HORSHAM DISTRICT COUNCIL CONSULTATION

TO:	Horsham District Council – Planning Dept
LOCATION:	Kilnwood Vale Sub-Phase 3DEFG Kilnwood Vale Crawley Road Horsham
DESCRIPTION:	Approval of details reserved by conditions 3,5,7 and 10 to approved applications DC/23/0856
REFERENCE:	DISC/24/0306
RECOMMENDATION:	Modification

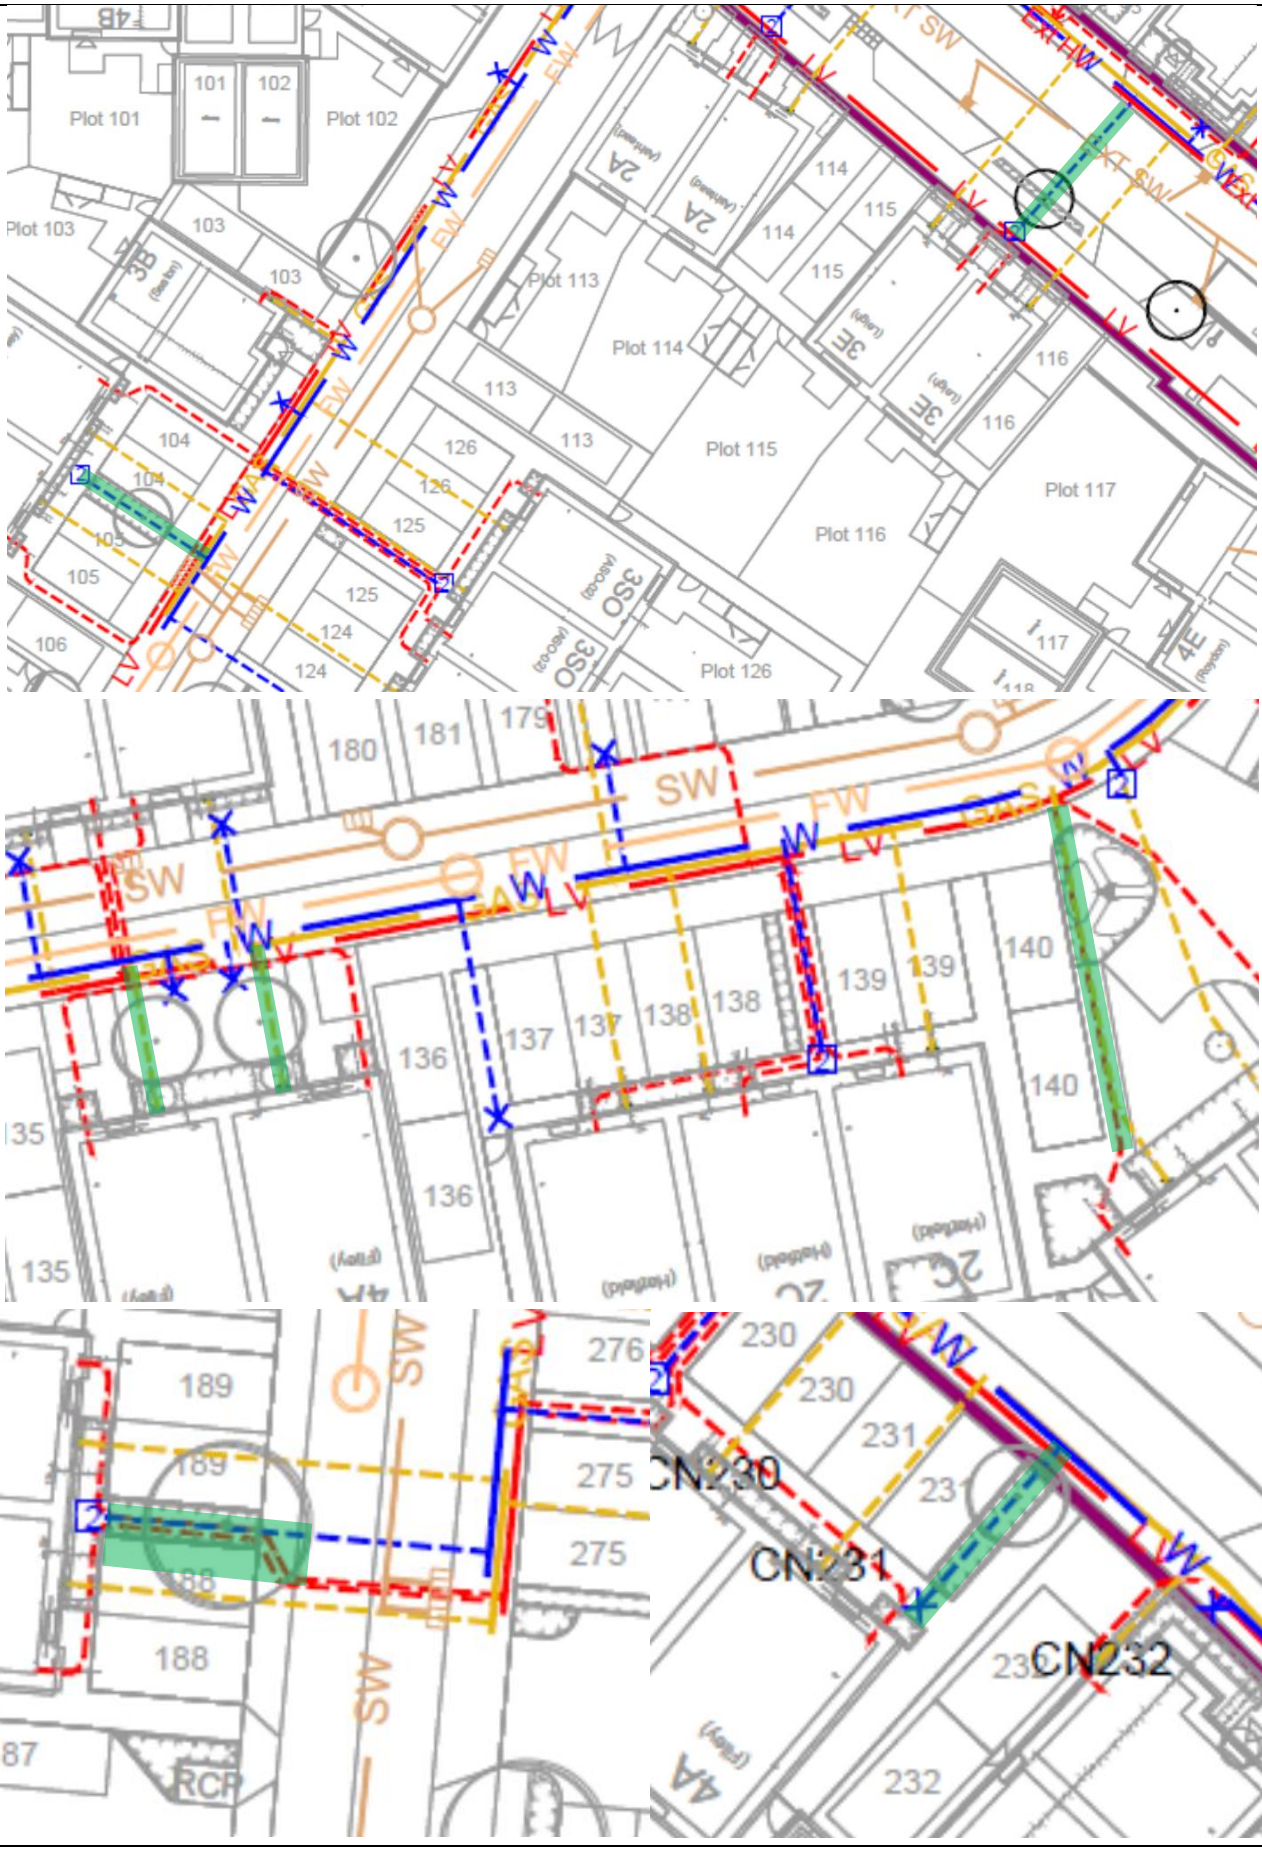
Concern is raised with the conflict between underground services and the landscape proposals. The Combined Services layout results in multiple examples of utilities being located underneath or within the RPA of proposed trees, therefore the trees are unlikely to be delivered and/or unlikely to be able to establish and be retained in the long term. The proposed trees are key to the general amenity of the development, therefore the underground services must be repositioned to avoid potential or future conflict, thereby securing both strategies. In addition, we recommend using a single trench for services to minimise disturbance to soils.

The following highlights (indicated in green, below) are examples of areas of conflict where the utilities are requested to be relocated. The purple highlights are examples where the proposed tree can be repositioned slightly. These examples, however, are by no means exhaustive.

Please note in addition that where in close proximity to utilities, the inclusion of tree root barriers is requested to ensure successful delivery and establishment.
